UNITED STATES PATENT AND TRADEMARK OFFICE

APPLICATION NO.	FILING DATE	FIRST NAMED INVENTOR	ATTORNEY DOCKET NO.	CONFIRMATION NO.
10/578,386	05/03/2006	Helmut Jerg	2003P01287WOUS	1892

Office Action Summary	Application No. 10/578,386	Applicant(s) JERG ET AL.	
	Examiner JASON P. RIGGLEMAN	Art Unit 1711

DETAILED ACTION

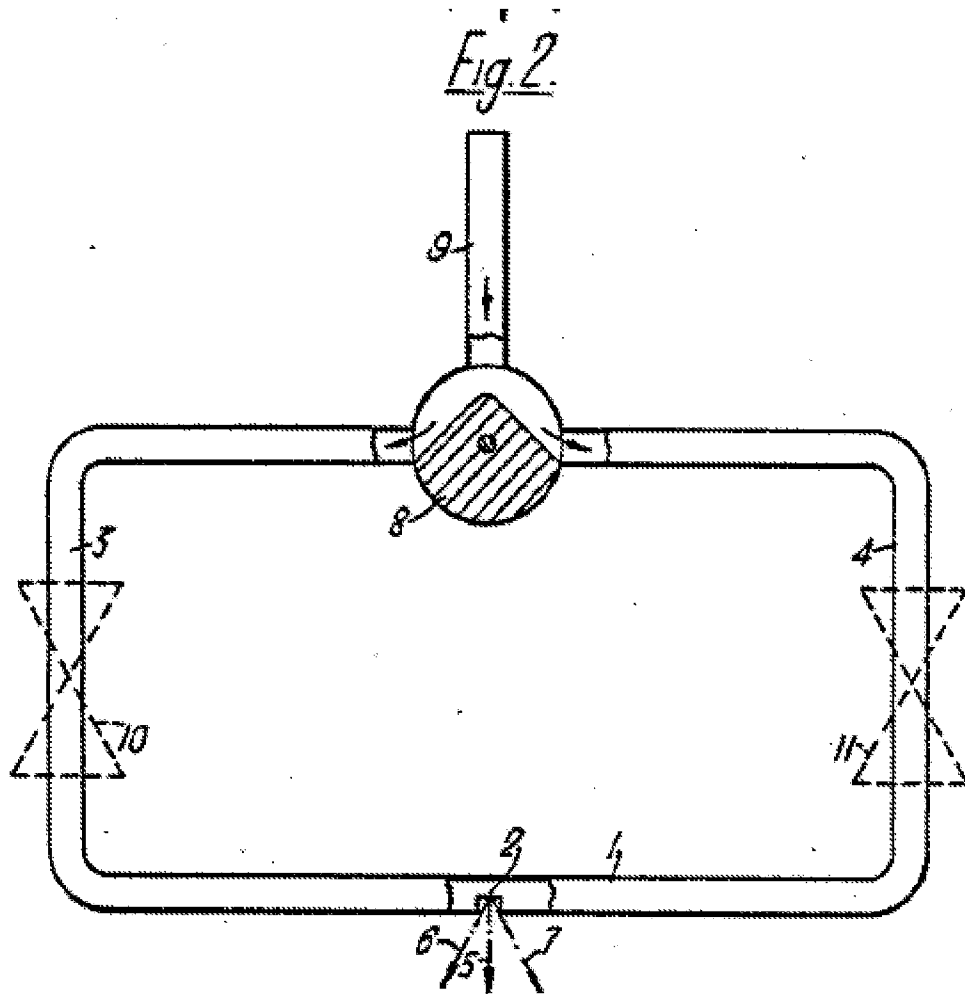
Further, Steen teaches feeding liquid under pressure, towards one another, two columns of liquid which collide to create a lateral spray at the point of collision to create pulsating pressure actions of different phase (Lines 24-39).

10. The pulsing permits fine control of the angle of spread of the spray (Lines 45-50), see Fig. 2, inserted into text, above. It would have been obvious to one of ordinary skill in the art at the time of the invention to modify Lutolf with the teachings of Van Dijk and Steen to create a washing machine in which there is fine control of the pulsing of the
